MIL-C-19803F  
AMENDMENT 6  
02 April 2001  
SUPERSEDING  
AMENDMENT 5  
29 September 1995

CONVERTER, LIQUID OXYGEN, 10 LITER, GCU-24A/A

This amendment forms a part of MIL-C-19803F, dated 24 March 1982, and is approved for use by all Departments and Agencies of the Department of Defense.

FIGURE 3. Front view.

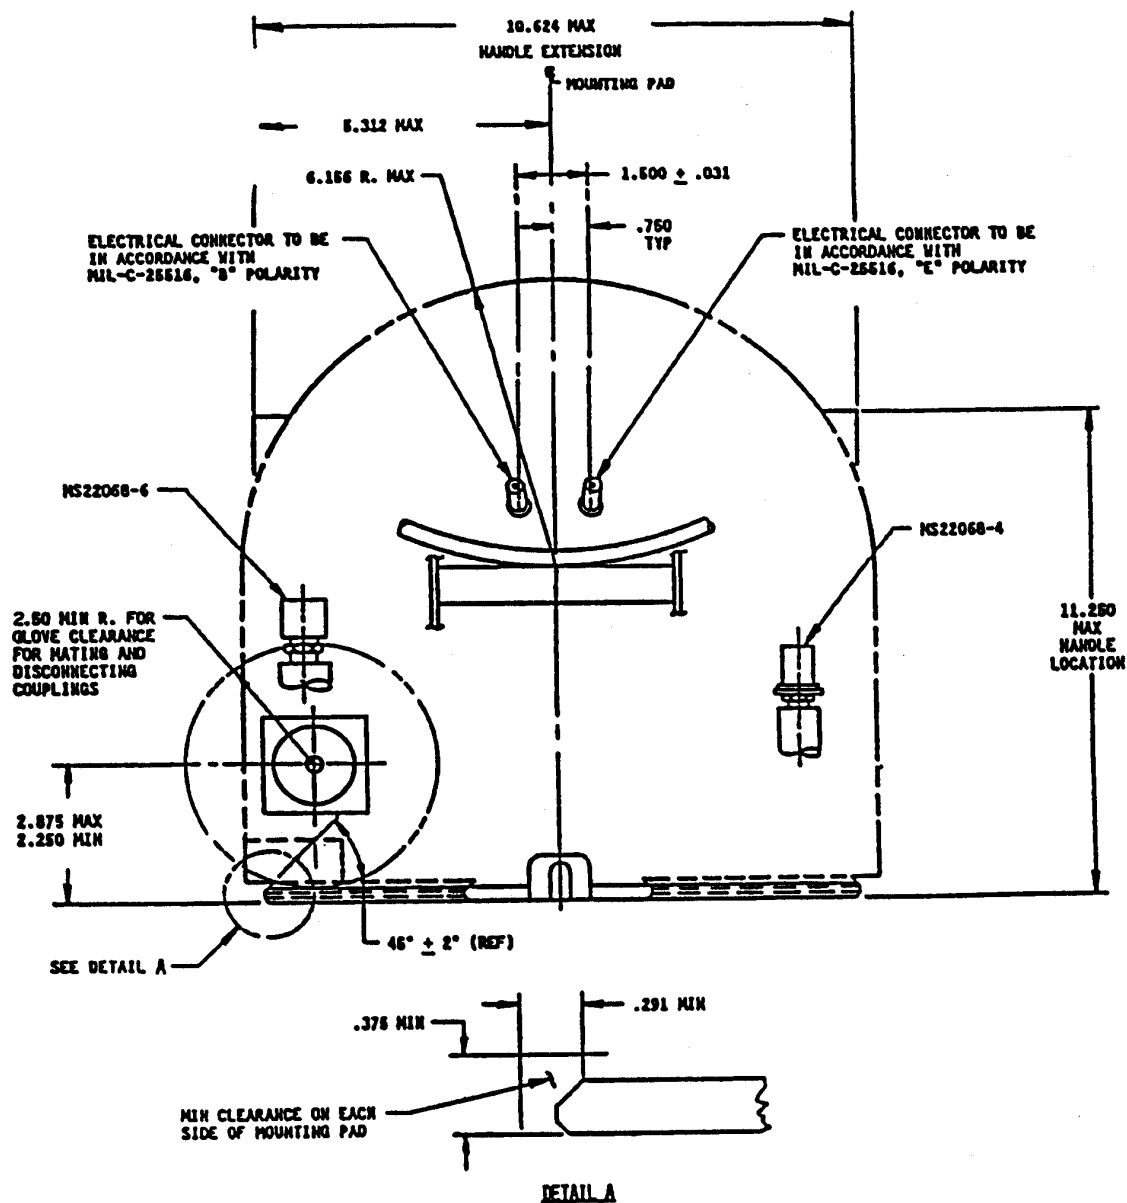
Figure 3: Delete and substitute new figure 3.

FIGURE 4. Mounting base.

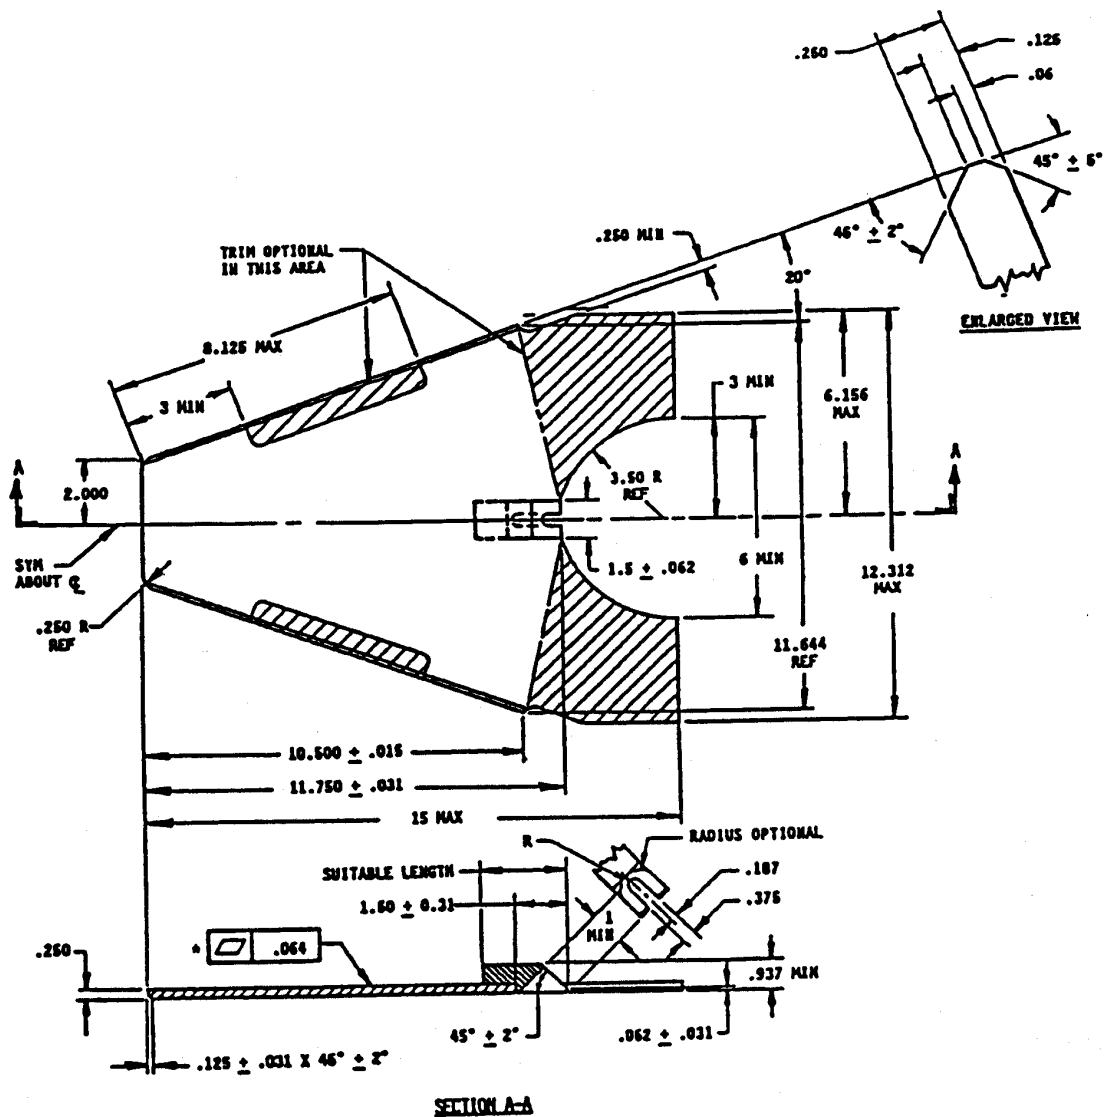
“3.6.13 Mounting base. The mounting base shall conform to the configurations and dimensional requirements of figure 4.”

Figure 4: Delete and substitute new figure 4.
